Wisconsin Department of Transportation

Proposal #03: 1000-57-70, FR-CRS-0068-2
Milwaukee Airport 2nd Platform
RR Crossing 393023R to 1200 FT South
STH 119
Milwaukee County

This is Addendum No. 01, which provides for the following:

ADDENDUM NO. 01
PROJECT ID 100-57-70
March 30, 2023

ENLARGED INTERMEDIATE LEVEL CONSTRUCTION PLAN
SCALE: 1/4"=1'-0"

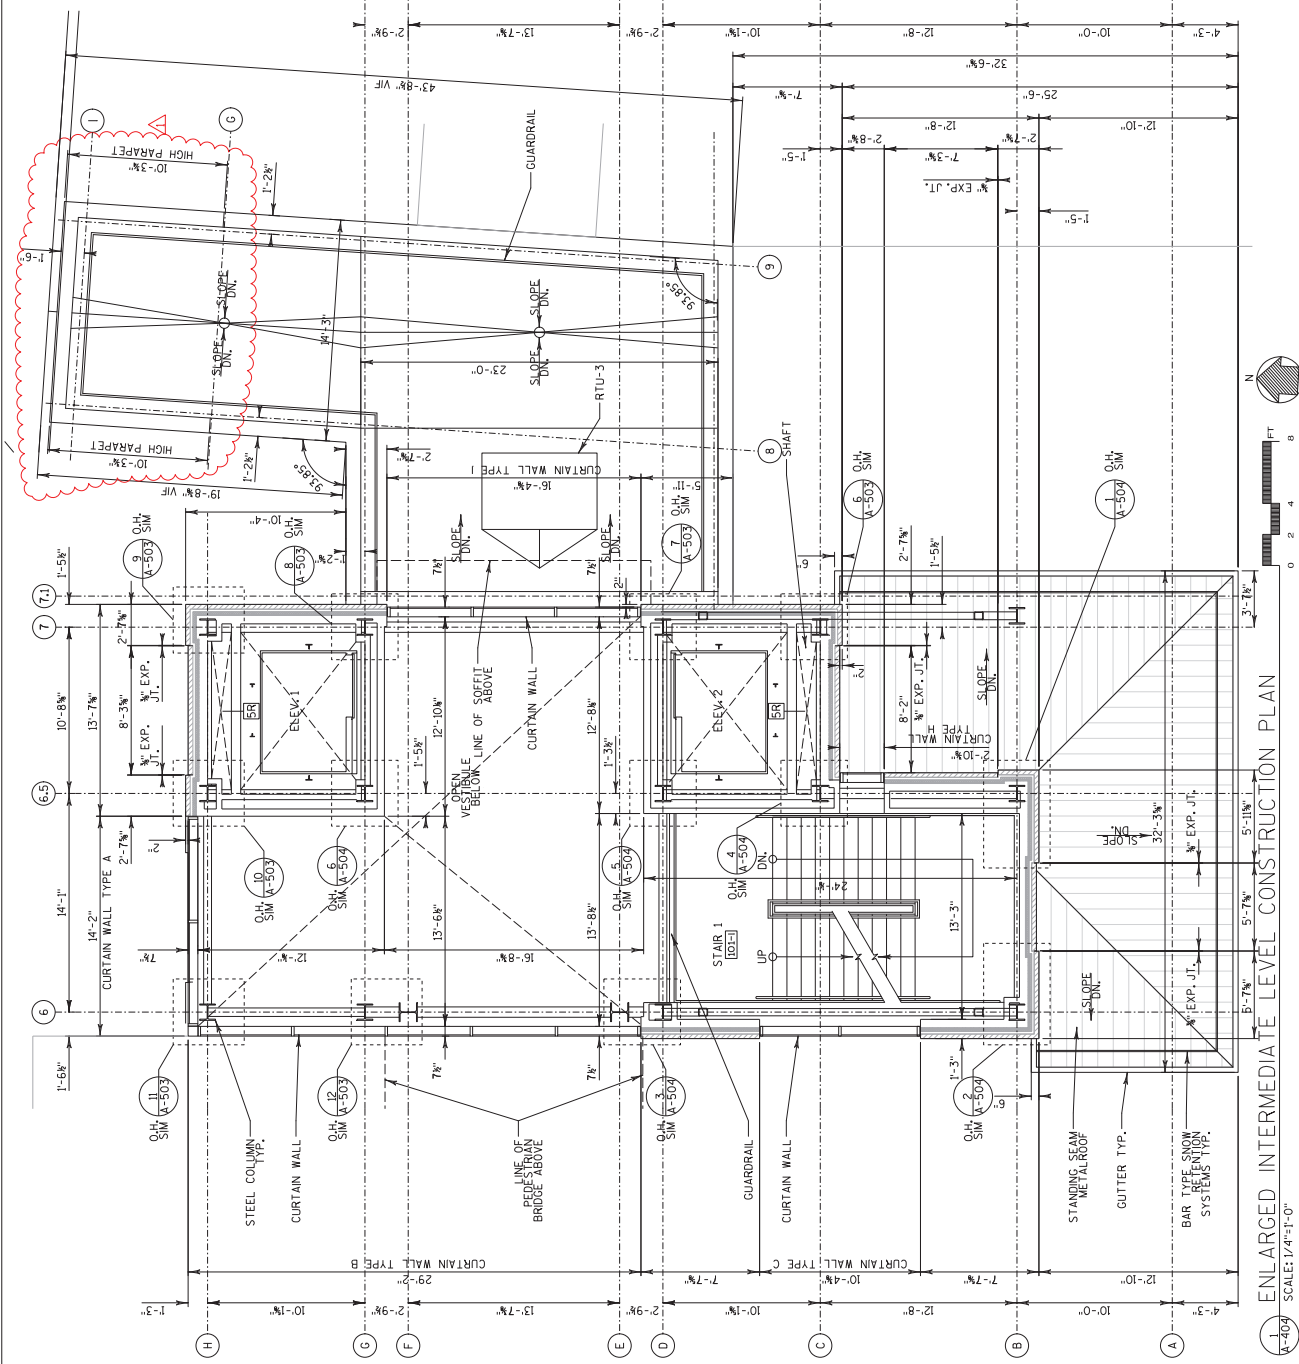
NO.	DATE	REVISION	BY
1	3/27/23	PARAPET WALL	JR

NO.	DATE	REVISED DETAILS	BY
1	3/27/23		JR
STATE OF WISCONSIN DEPARTMENT OF TRANSPORTATION			
ARCHITECTURAL			
DRAWN BY: JR		PLANS CNO: DK	
SHEET A-502		FLOOR PLAN DETAILS	
154

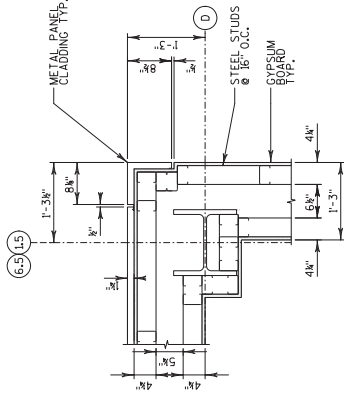
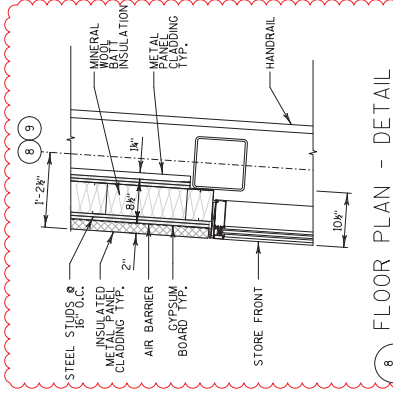
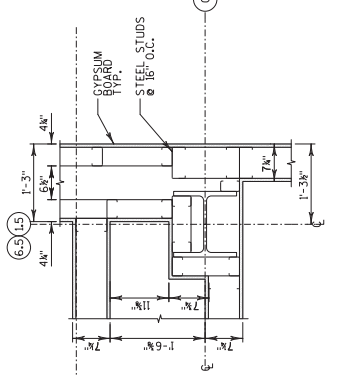
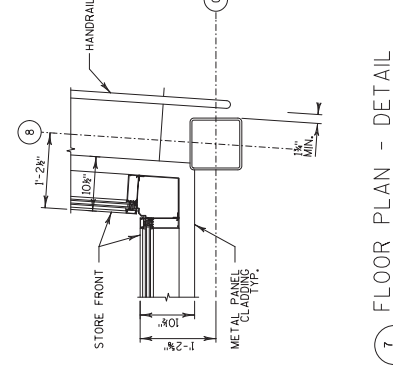
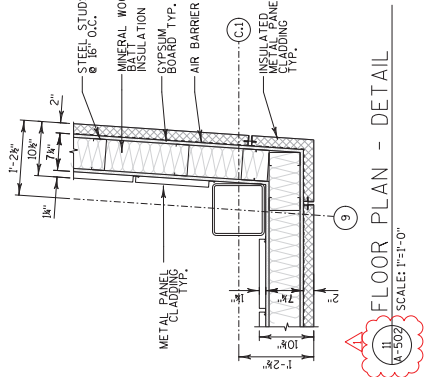
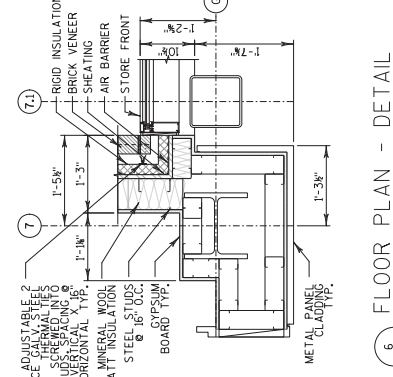
102	G-002 Added tables 8, 9, 10, and 11. Revised occupancy group for rooms 109 and 111 on table 2.
103	G-003 Revised fire rated wall on 1 st floor egress plan and fire rated roof on Int. level egress plan.
114	A-111 Added existing restroom and existing drinking fountain to existing building. Revised location of grid line "I" and revised passage's walls and store fronts.
115	A-112 Revised location of grid line "I" and revised passage's parapet walls.
119	A-120 Revised location of grid line "I" and revised reflected ceiling plan
126	A-201 Revised Note
127	A-202 Revised east elevation at East Tower
130	A-303 Revised keynotes
131	A-304 Revised keynotes
132	A-305 Revised keynotes
133	A-306 Revised elevations and partial plan
143	A-402 Revised Passage's walls, dimensions, and reference numbers.
145	A-404 Revised parapet wall.
154	A-502 Removed detail 9/A-502 replaced with modified detail 10/a-502. Detail 10/A-502 replaced with 11/A502 and detail 12/A-502 renamed to 11/A-502.

NO.	DATE	REVISED DETAILS	BY
1	3/27/23	REVISED DETAILS	JR
STATE OF WISCONSIN DEPARTMENT OF TRANSPORTATION			
ARCHITECTURAL			
DRAWN BY: JR			DK
SHEET A-503			
FLOOR PLAN DETAILS			155

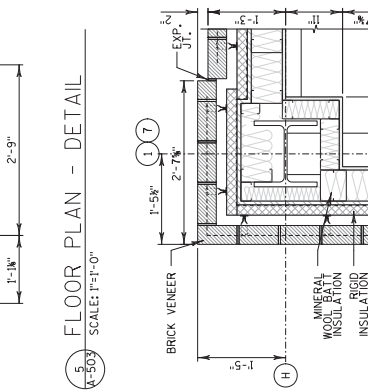
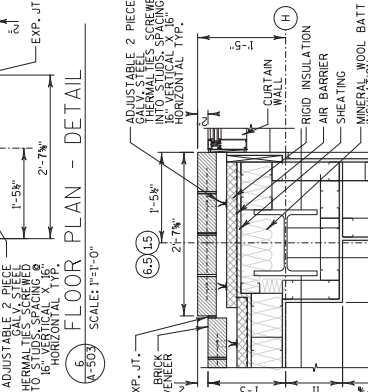
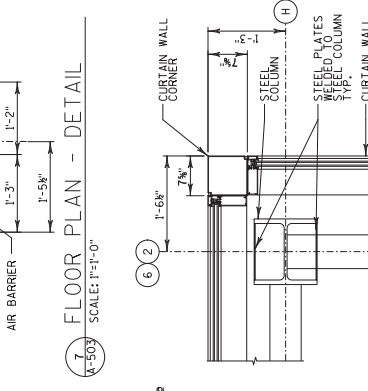
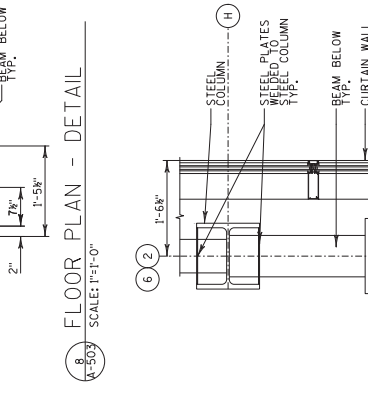
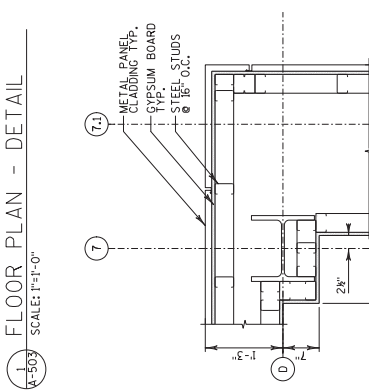
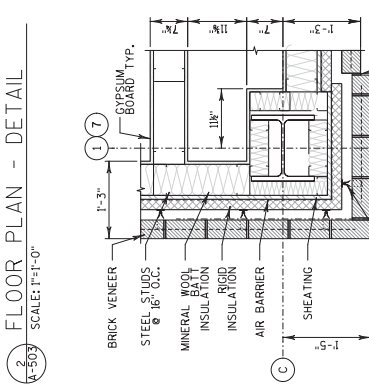
155	A-503 Revised details 2/A-503 and 3/A-503
173	A-524 Removed detail 6/A-524
177	A-606 Revised curtain wall types E, F and G
255	T-712 Camera Detail

ENLARGED PASSAGE FLOOR PLAN FIRE RATED WALL DETAILS

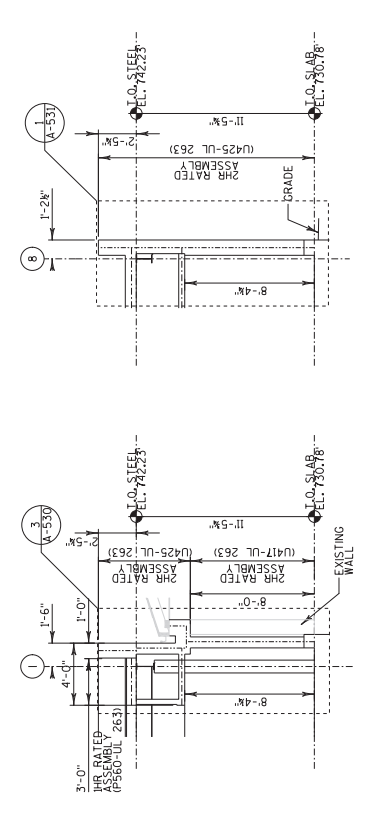
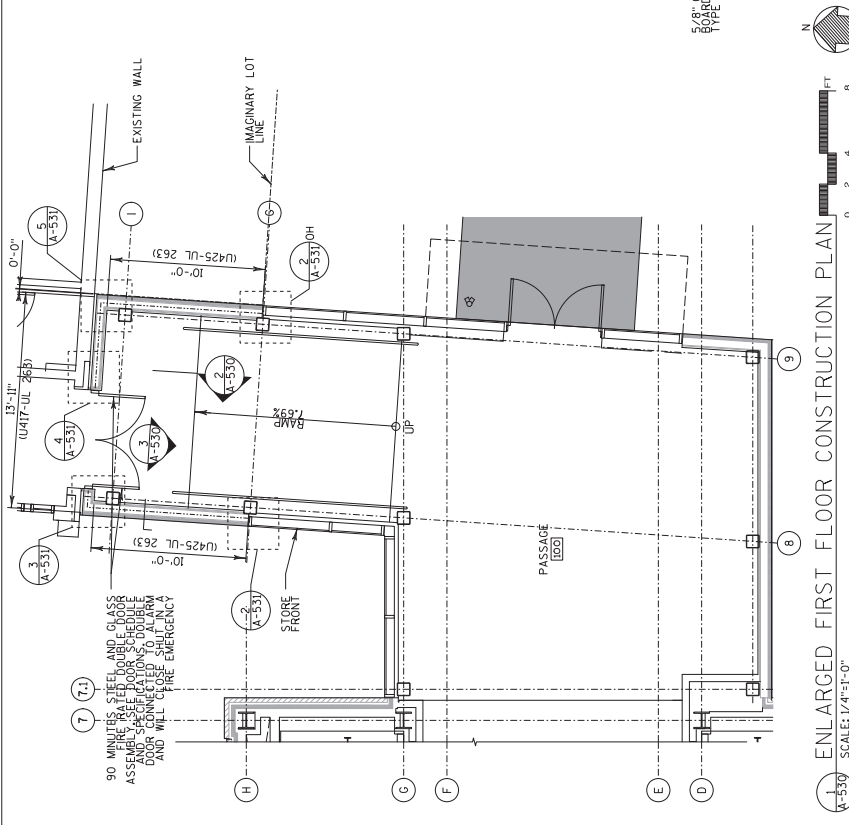
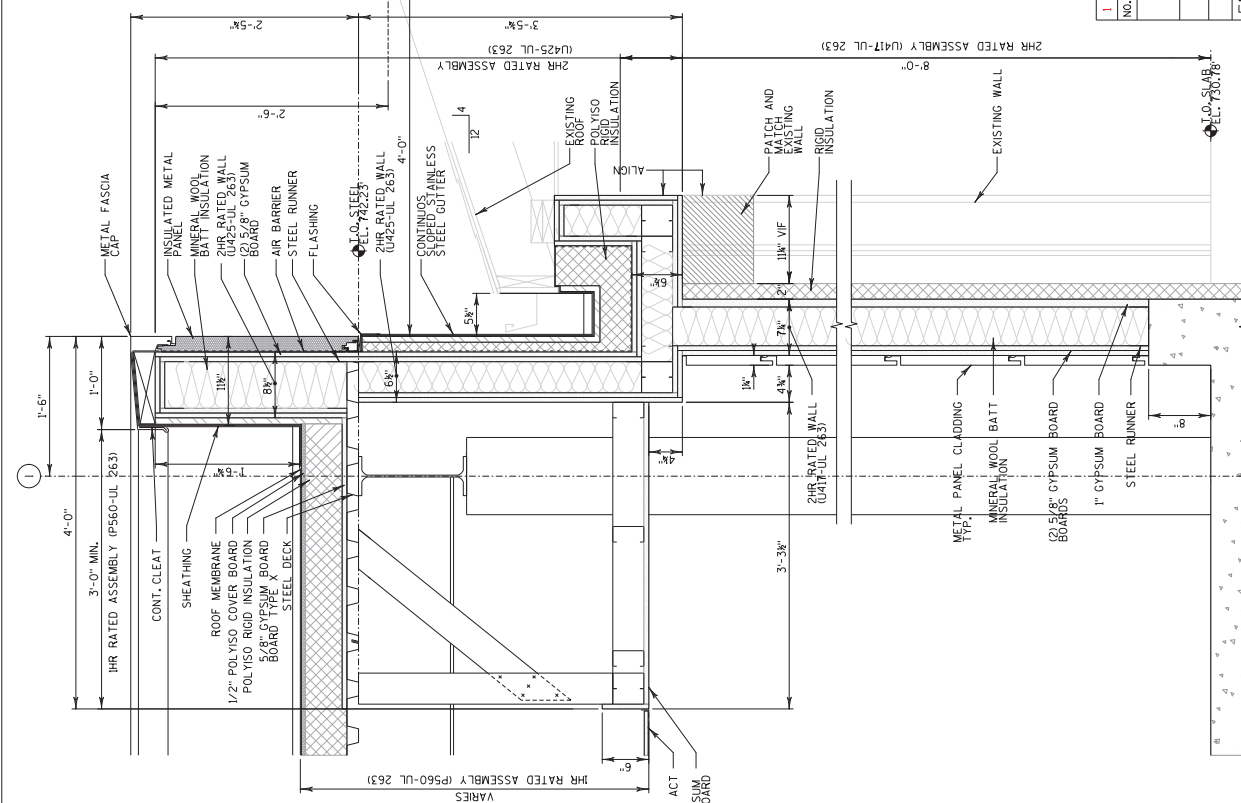
Added Plan Sheets	
Plan Sheet	Plan Sheet Title (brief description of why sheet was added)
173A	A-530: Enlarged Passage Floor Plan, Fire Rated Wall Details added in order to address the 2 HR rated assembly separating the existing building.
173B	A-531: Passage Fire Rated Wall Details added in order to address the 2 HR rated assembly separating the existing building.

1 CURTAIN WALL TYPE E
SCALE: 1/4"=1'-0"

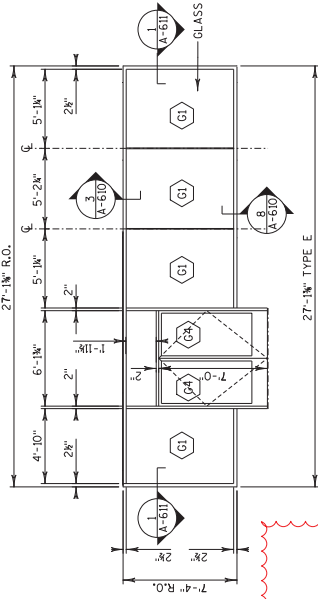
NO.	DATE	REVISED CURTAIN WALL TYPES	JR
1	3/27/23	REVISION	BY
STATE OF WISCONSIN DEPARTMENT OF TRANSPORTATION			
ARCHITECTURAL			
DESIGNED BY		JR	DK
CHECKED BY		JR	DK
DRAWN BY		JR	DK
PROJECT NO.		A-606	
SHEET		A-606	
TOTAL SHEETS		177

SCALE: NTS
T-712
VIDEO BLOCK DIAGRAM

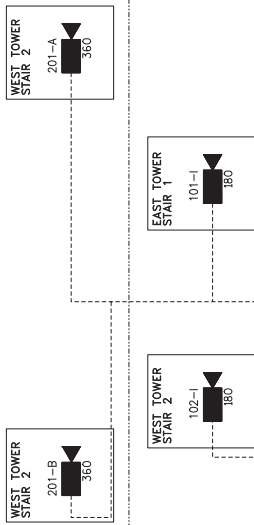
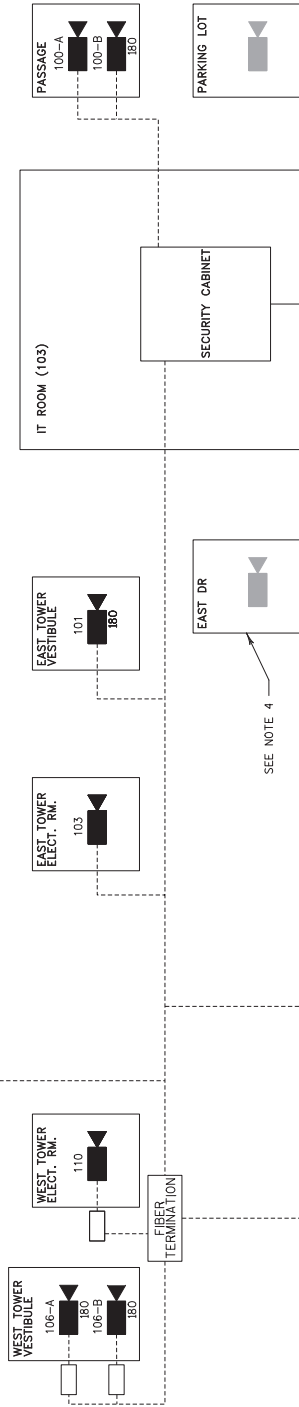
NO.	DATE	REVISION	BY
1	3/27/23	CAMERA DETAIL	MC
STATE OF WISCONSIN DEPARTMENT OF TRANSPORTATION			
COMMUNICATIONS			
DRAWN BY		MC	TS
CHECKED BY		MC	TS
SHEET T-712			255
CCTV BLOCK DIAGRAM
